Revision to a Request for a Standing Offer

Title - Sujet NISO Custom Lapel Pins NISO Custom Lapel Pins	
Solicitation No. - N° de l'invitation 51019-220926/A	Date 2022-05-30
Client Reference No. - N° de référence du client 51019-220926	Amendment No. - N° modif. 001
File No. - N° de dossier MCT-1-44186 (042)	CCC No./N° CCC - FMS No./N° VME
GETS Reference No. - N° de référence de SEAG PW-\$MCT-042-6208	
Date of Original Request for Standing Offer Date de la demande de l'offre à commandes originale 2022-05-06	
Solicitation Closes - L'invitation prend fin at - à 02:00 PM Atlantic Daylight Saving Time ADT on - le 2022-07-05 Heure Avancée de l'Atlantique HAA	
Address Enquiries to: - Adresser toutes questions à: Stockman (MCT), Sonia	Buyer Id - Id de l'acheteur mct042
Telephone No. - N° de téléphone (506) 961-7412 ()	FAX No. - N° de FAX (506) 851-6759
Delivery Required - Livraison exigée	
Destination - of Goods, Services, and Construction: Destination - des biens, services et construction:

Amendment 001

ANNEX "F" DRAWING OF BOOT PIN (revised May 30, 2022)

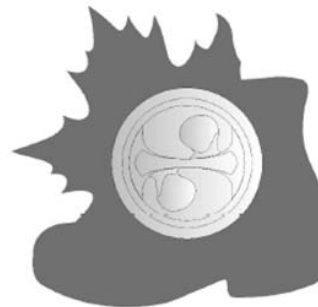
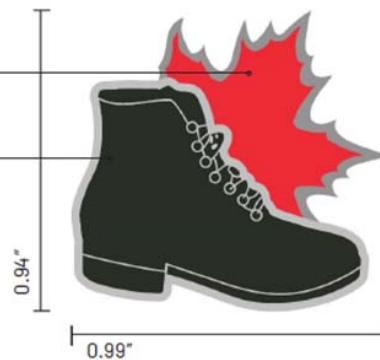
Q8. For the boot pin, please clarify if this is to be developed as a boot shaped Lapel Pin. In the RFQ no specifications are mentioned for this style, pls advise us details of size, etc. for quotation reference purposes.

A8. **Boot pin is 0.99" x 0.94" and 2mm and 3 mm in thickness. Specifications provided.**

- 1st level (highest) - 3mm
- 2nd level - 2mm
- Pantone 032 C
- Pantone Black C

- a) Red
Pantone 032 C
- b) Black
100% Black or
Pantone Black C
